QUESTION 2H.1 (DRL 2.7) Discuss the water flow patterns in the vicinity of the plant and their associated consequences on plant operations following a failure of the on-site water storage facilities.

QUESTION  
2H.2  
(DRL 2.8)

Docket 50-312  
Amendment No. 2  
April 15, 1968  
Appendix A to Question 2H.2

FIGURE 2H.2-1  
EARTHQUAKE EPICENTERS  
1941-1966

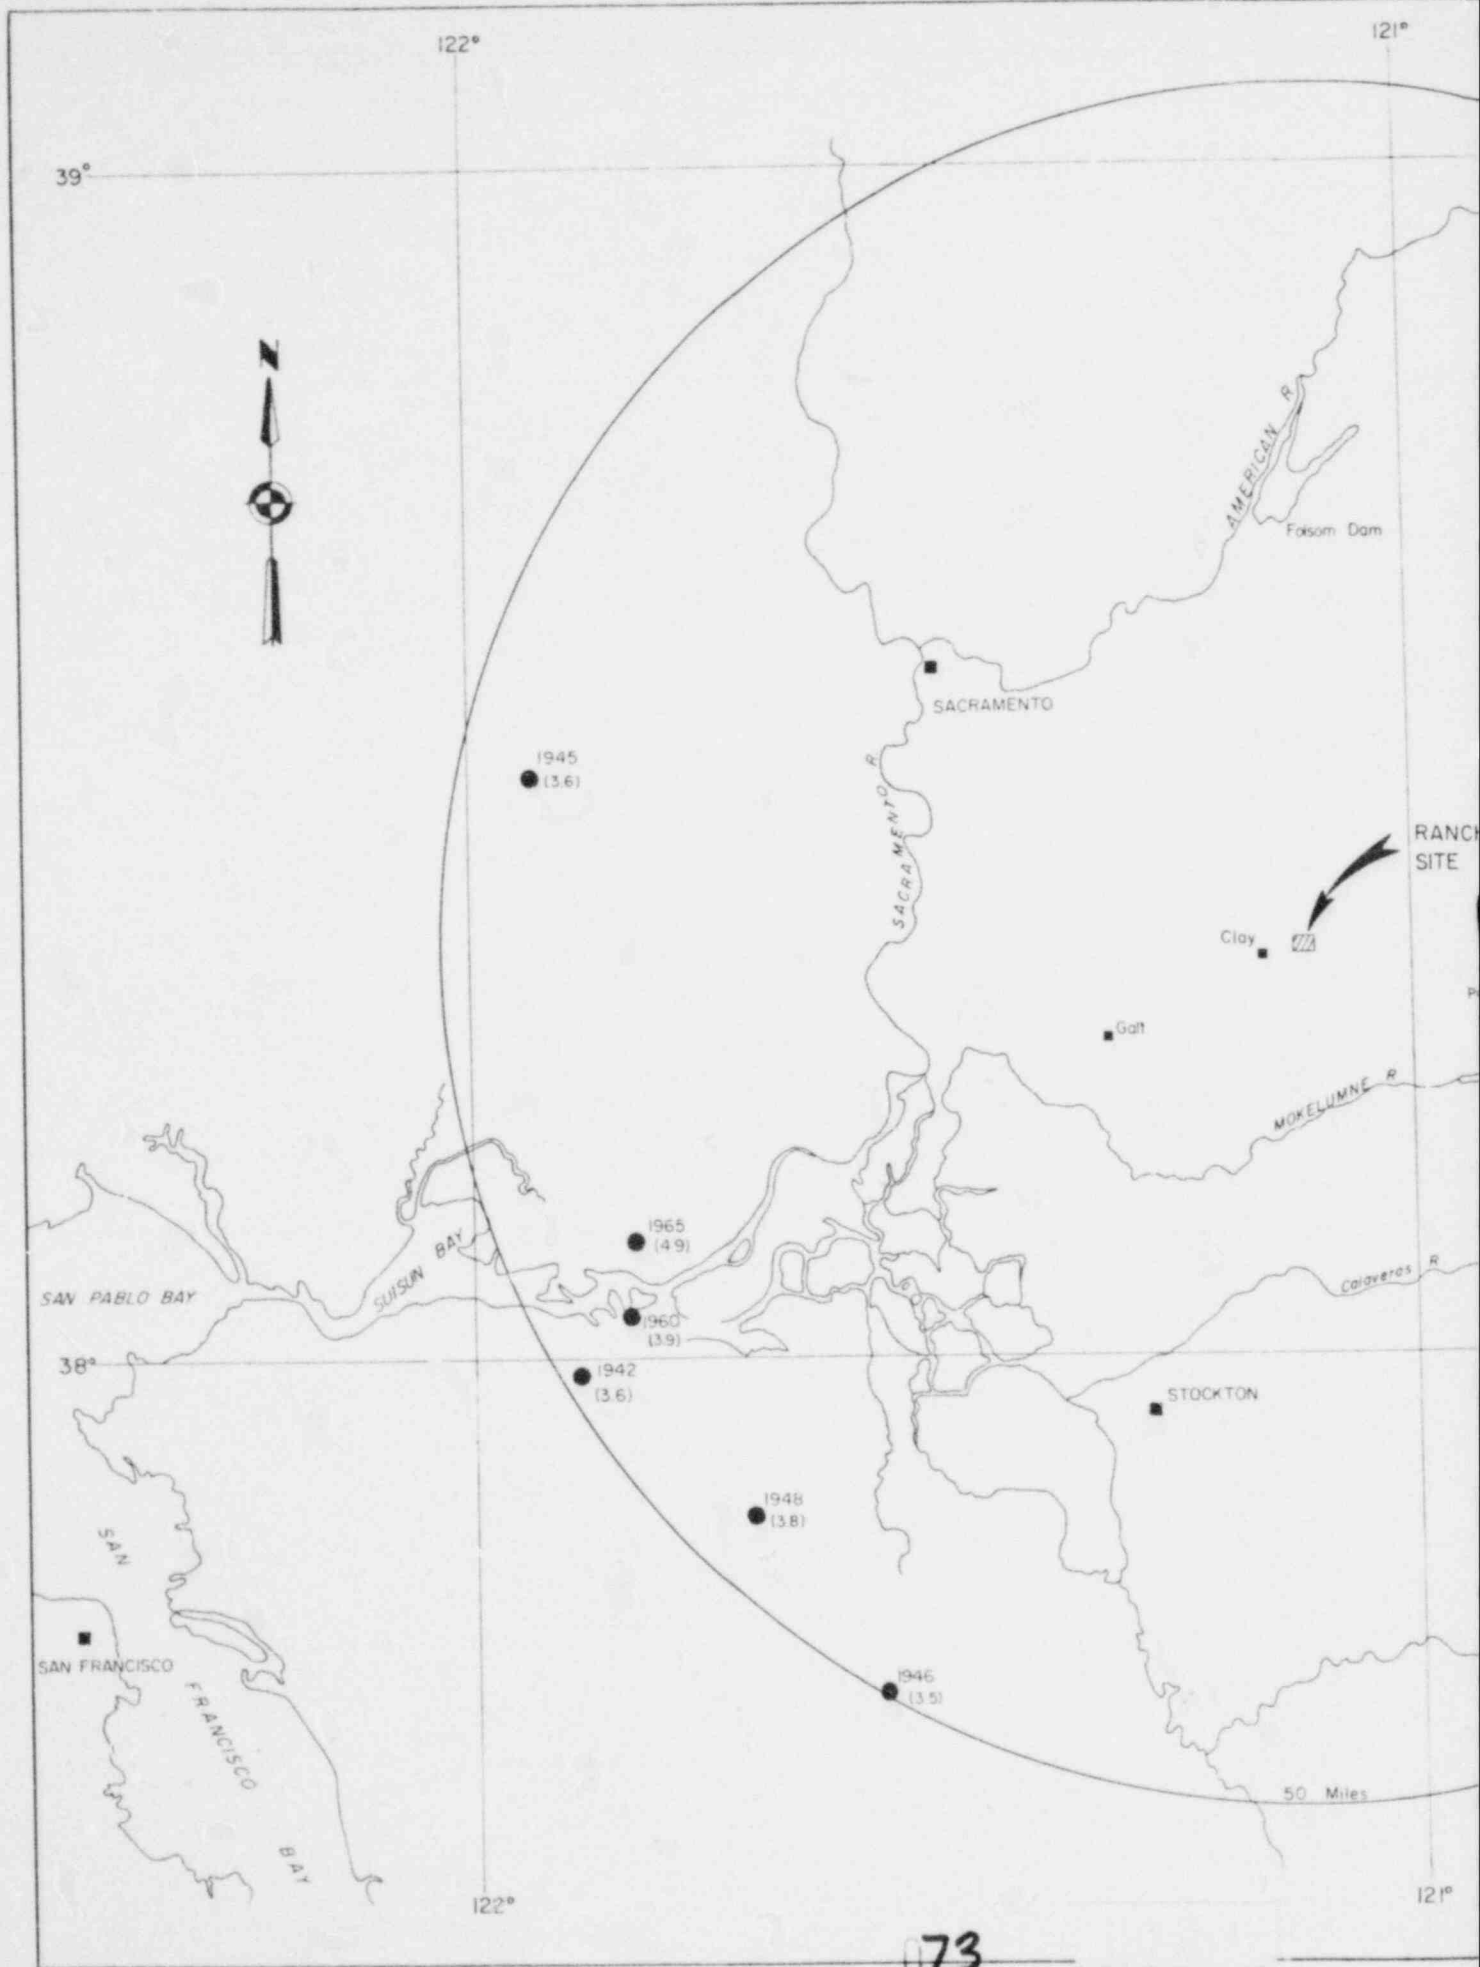
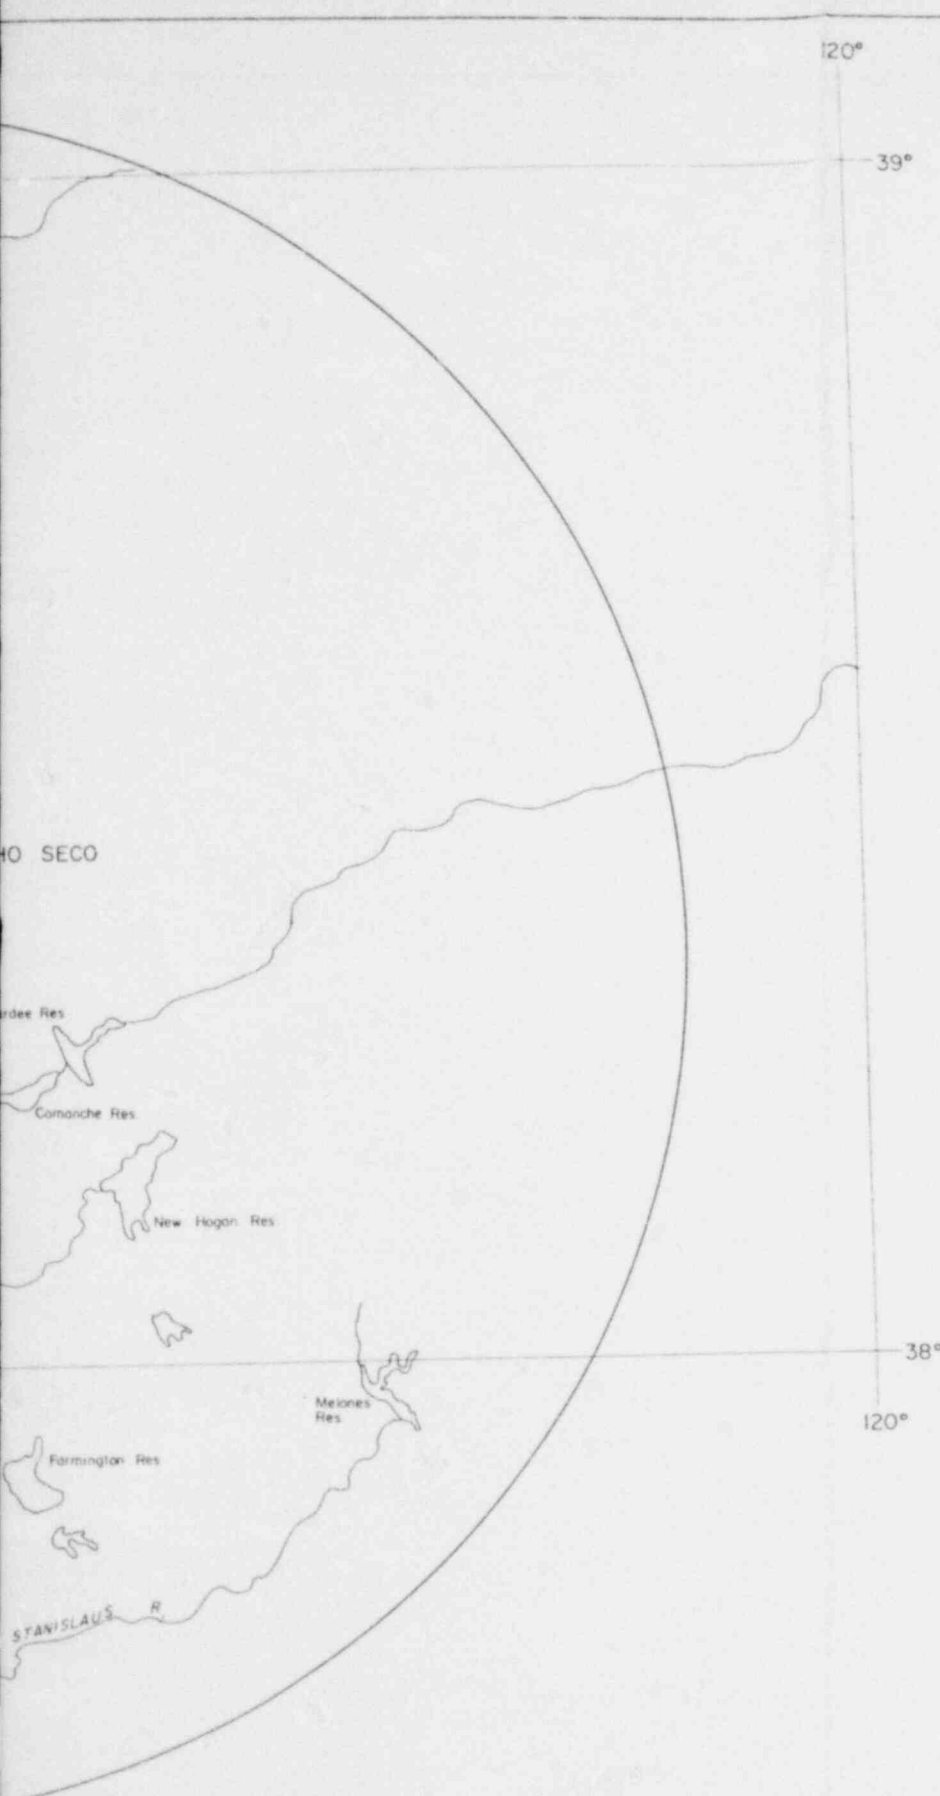
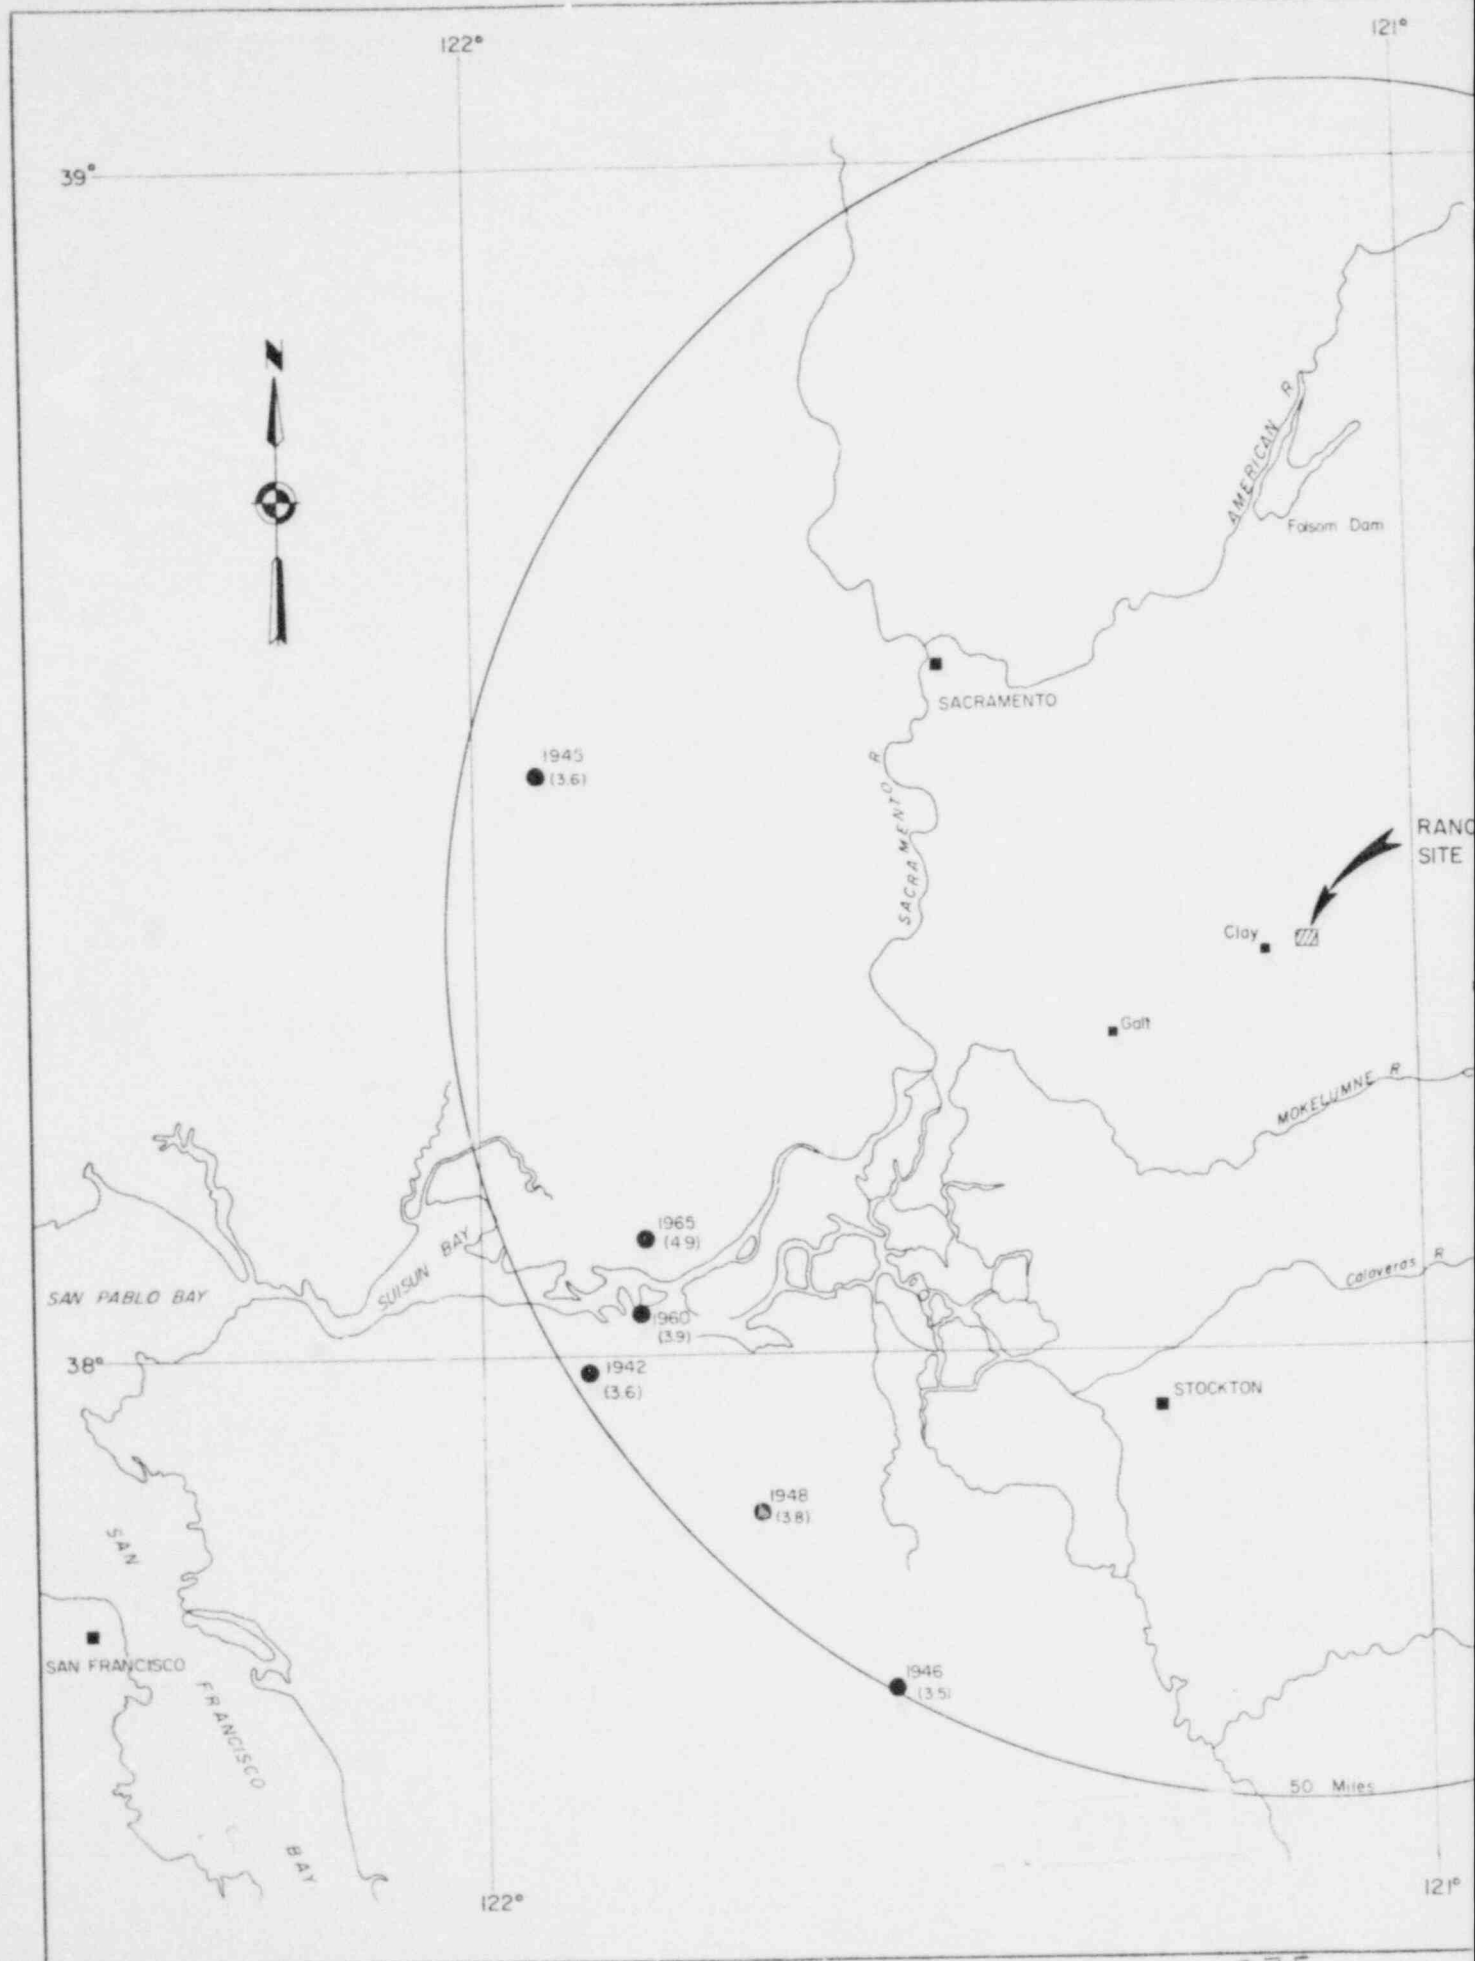
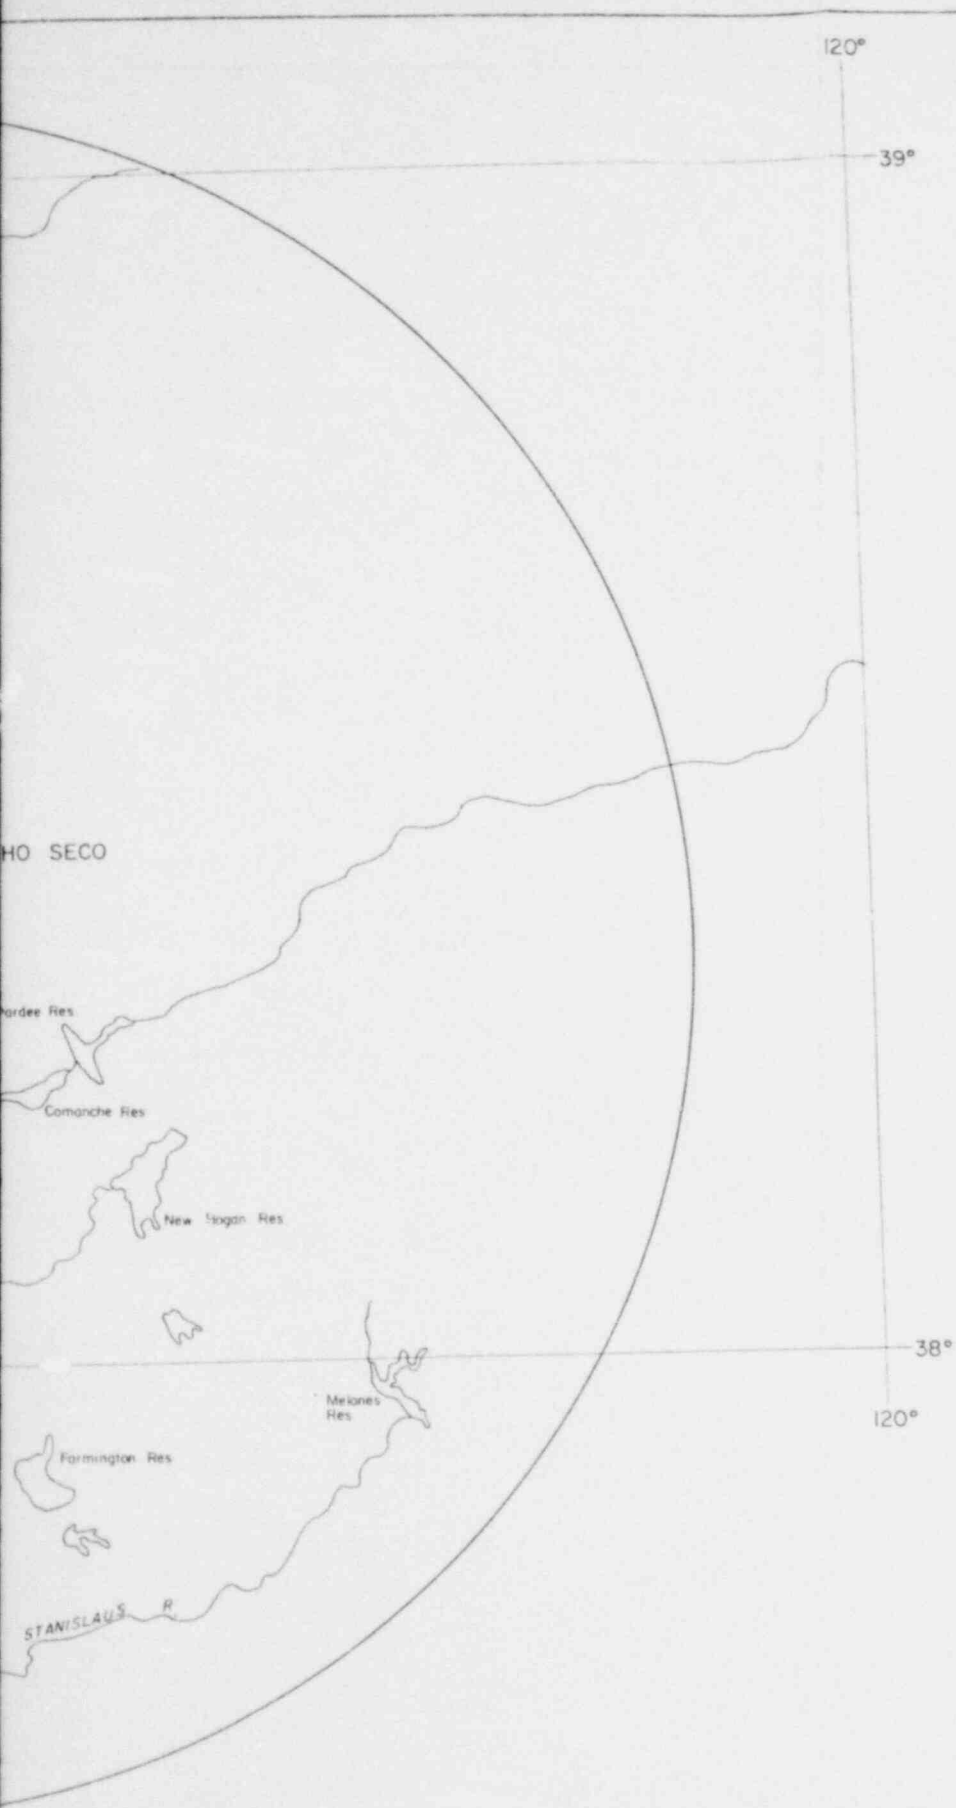
Provide a map of earthquake epicenters within a radius of 200 miles showing all earthquakes of intensity V or greater at the epicenter.

The instrumented epicenters and non-instrumented seismic events within a 50 mile radius of the Rancho Seco site are shown on Figures 2H.2-1 and 2 respectively.

The epicenter map shows the magnitude of earthquakes actually recorded, while the non-instrumented seismic event map shows the highest intensity reported for any earthquake. It is considered that the 50 mile radius map presents a meaningful description of the site and adjacent area since varying geological conditions need not be evaluated. Similar maps for a 200 mile radius are shown in Figures 2H.2-3 and 4.

Appendix A to this answer is Professor Byerly's explanation of epicenter maps (Figures 2H.2-1 and 2).
